**Flood Control Project Maintenance  
Levee Inspections**

## Maintenance Issue Types Only, Levee Inspection Report By Mile - Spring 2017

### Reclamation District No. 0017 Mossdale

Photo 1 of 1 : SP\_2017\_RD0017\_303\_9\_20170330\_00018.jpg

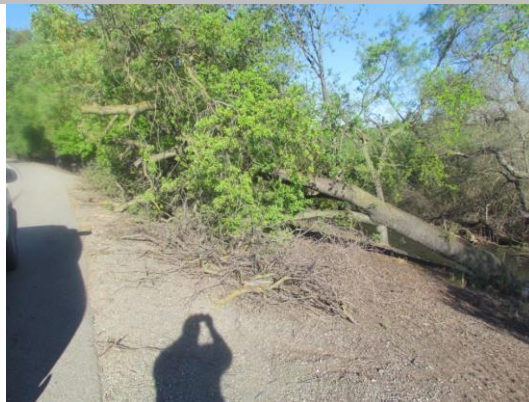
LM Start	0.28	Rating **	M	Issue No.	9	
LM End	0.28	Issue Type +	Ma	Location *	WS	
Category	Earthen Levee			GPS Latitude/Longitude		
				Start	End	
Item	Encroachments			37.913503 °	37.913503 °	
				-121.294952 °	-121.294952 °	
DWR ID	DWR_RD0017_01_s_2017_9					
Comment Code						
TR : Tree or limb						
Inspector Comment						
Fallen tree on waterward slope.

Looking northeast at fallen tree on waterward slope.
